VALUE ENGINEERING CONSTRUCTABILITY STUDY
OF THE

SR 92/FAIRBURN ROAD INTERCHANGE WITH I-20

PROJECT NUMBER: IM-NH-20-1(73)

August 14-15, 2006

AS PROPOSED
SPREAD FOOTINGS

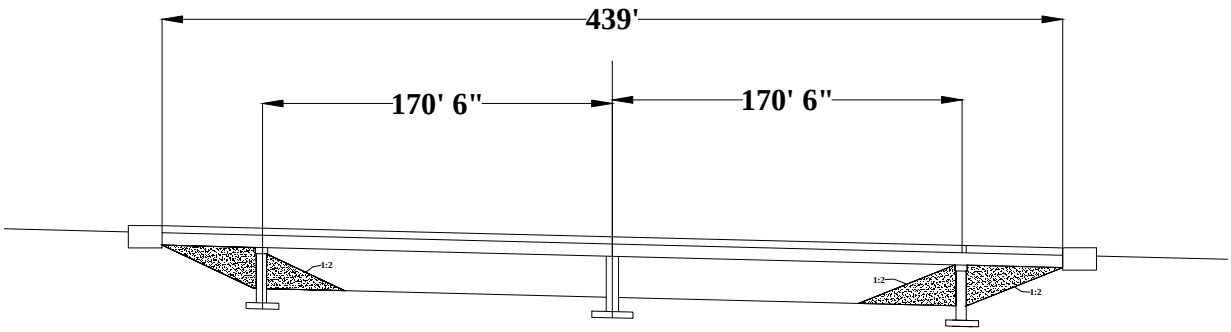
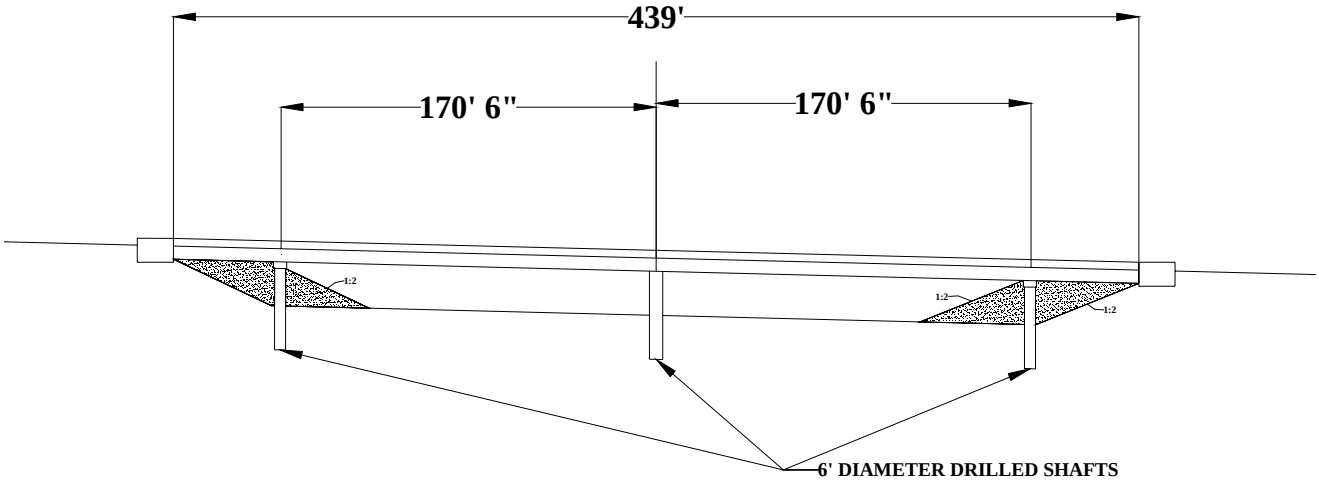
The as proposed consists of spread footing foundations at all interior bents. The footings for bent 3 are up to 22.5 ft. in the direction parallel to the centerline of the bridge. In the 40 ft. wide median, this leaves 9 ft. +/- from the edge of the footing excavation to the travel lane. These footings are 16 ft. below natural ground; so shoring will be required to protect traffic. Each bent consists of 8-columns on 3.5 ft. thick spread footings founded on rock or weathered rock.

The Value Engineering Alternative is to use drilled shafts under all columns at each bent. The shaft lengths include 10 ft. into rock or weathered rock. The top of rock elevation is taken as the bottom of the as proposed spread footings. The shaft diameter is estimated at 6 ft. +/-. The length of the shafts is based on the top of the shaft being at the ground line. Using round columns will facilitate the use of shafts. If the columns are slightly smaller than the drilled shafts, construction of the column on the shaft will be simpler and faster.
